Exhaust Flex Pipe Cracks

M-252-001

(January 2009)

All CXU,CHU,GU,TD models with MP7, MP8 built before May 2008

Revised Exhaust Flex and Turbocharger Outlet Pipes

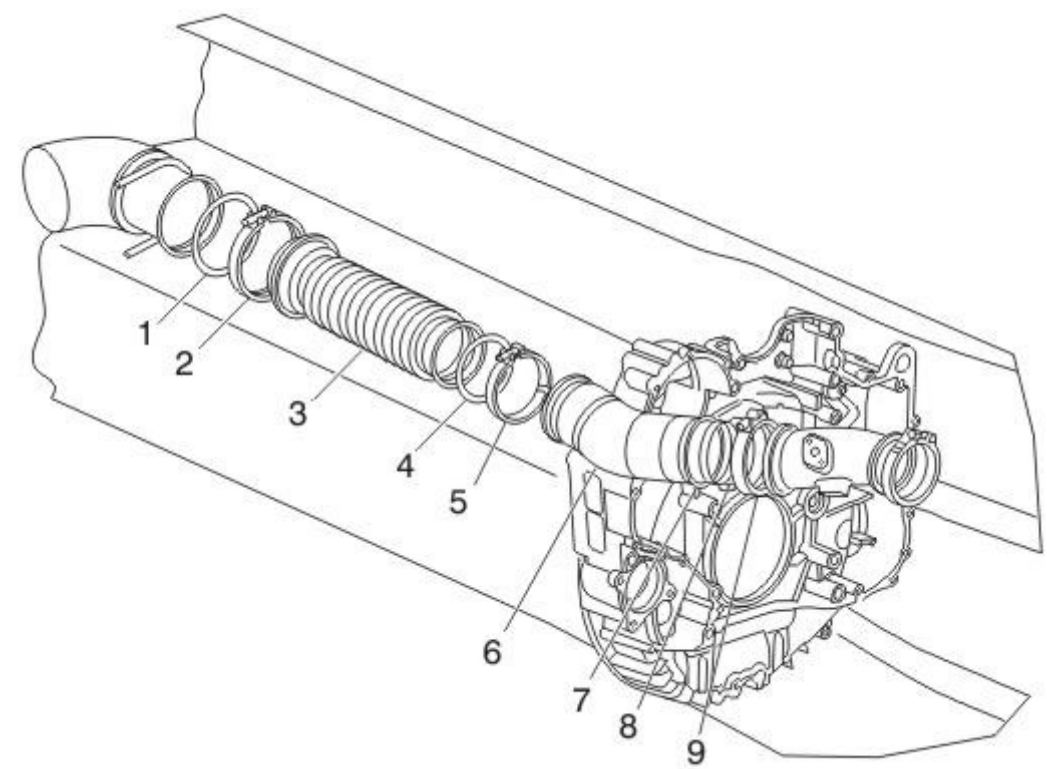
Effective May 9, 2008, a redesigned exhaust flex pipe and turbocharger outlet pipe (located between the turbocharger cast diffuser and the exhaust flex pipe) were implemented into production on CXU, CHU and GU model chassis. Both the turbocharger outlet pipe and the exhaust flex pipe were redesigned to improve exhaust pipe alignment, and the diameter of the inside liner of the flex pipe was reduced by 6.35 mm (1/4") to prevent contact with the pipe bellows. These changes were made to prevent the exhaust flex pipe from cracking. Should a cracked exhaust flex pipe be encountered on a chassis manufactured prior to May 9, 2008, the existing flex pipe and turbocharger outlet pipe should be replaced with these revised components.

Note: An exhaust pipe alignment ring (part number 20978469, key item 7 in the table above) was implemented into production approximately mid-October 2006. The cast diffuser and turbocharger outlet pipe include a counterbore to accept this ring. This ring is NOT used if the cast diffuser does not include the counterbore.

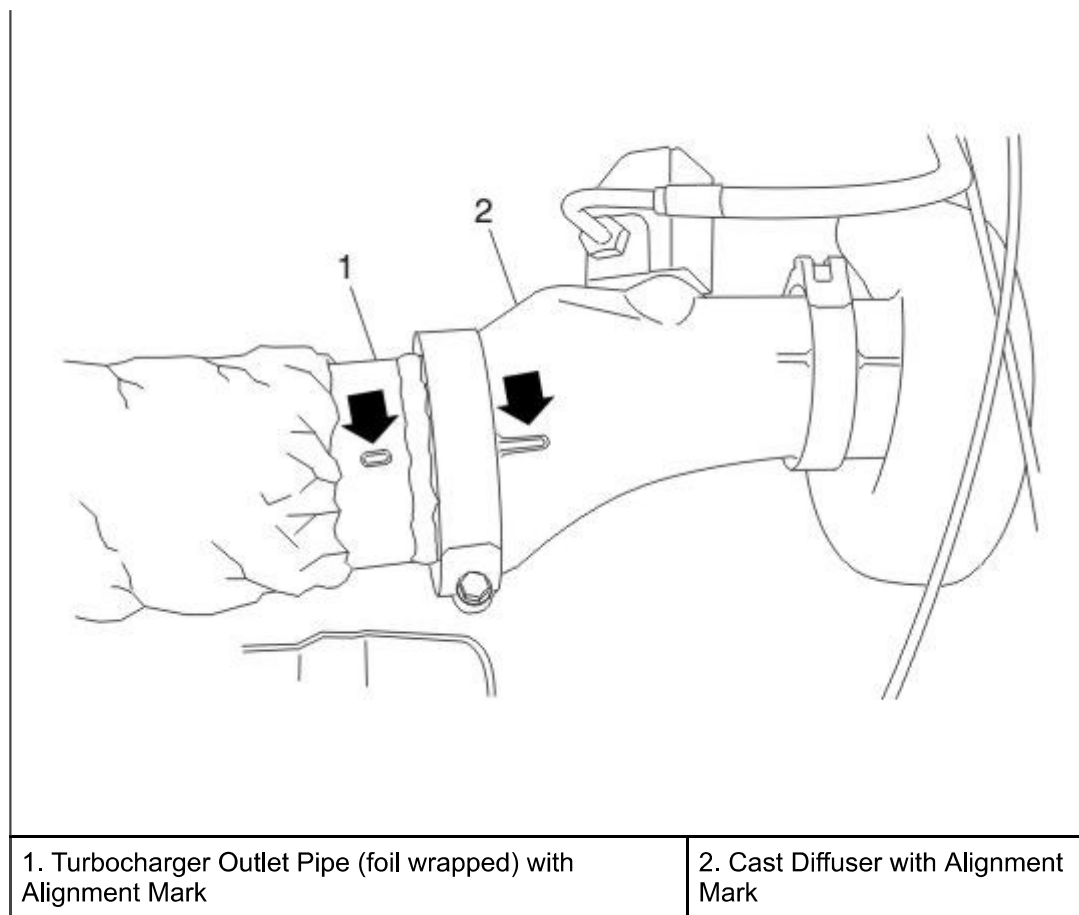
- 2. Verify that the alignment marks on the front of the turbocharger outlet pipe and the rear of the cast diffuser are directly opposite each other as shown in the following illustration.
